Amendments to the Drawings:

REMARKS

Fig. 6

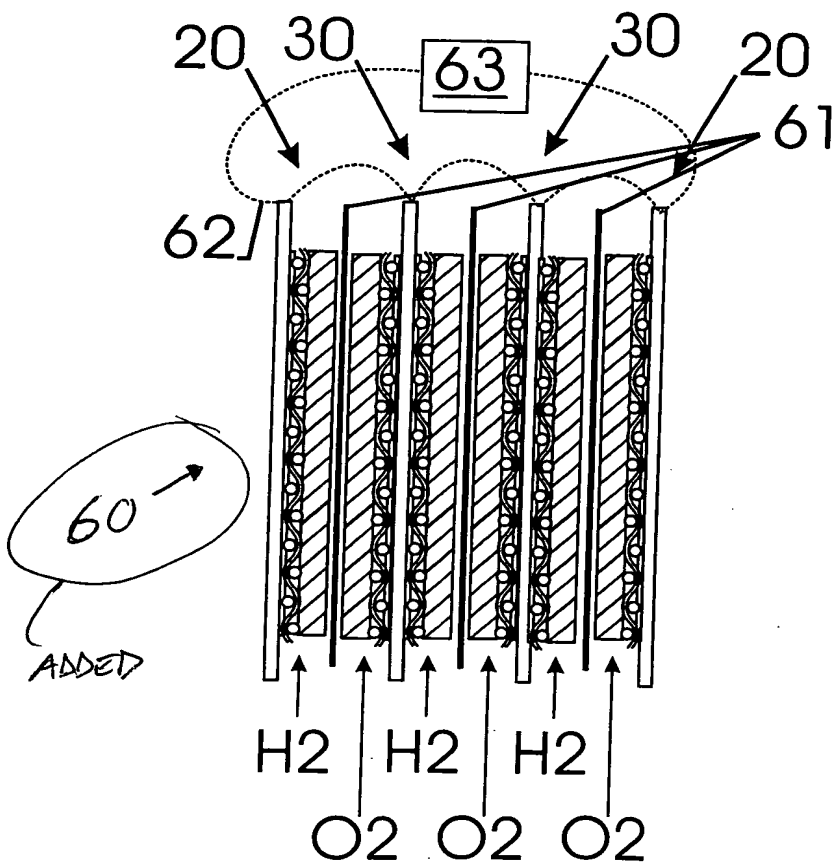
The specific changes which have been made to Figure 6 is to add reference numeral "60."

The drawings are objected to for containing informalities. Applicant respectfully submits that the amendment to the drawing renders this objection moot. Reconsideration and withdrawal of this objection is respectfully requested.

The drawing sheets attached in connection with the above-identified application containing Figures 5c, 6, and 7 are being presented as a new formal drawing sheets to be substituted for the previously submitted drawing sheets. The drawing Figure 6 has been amended. Appended to this amendment is an annotated copy of the previous drawing sheet which has been marked to show changes presented in the replacement sheet of the drawing.
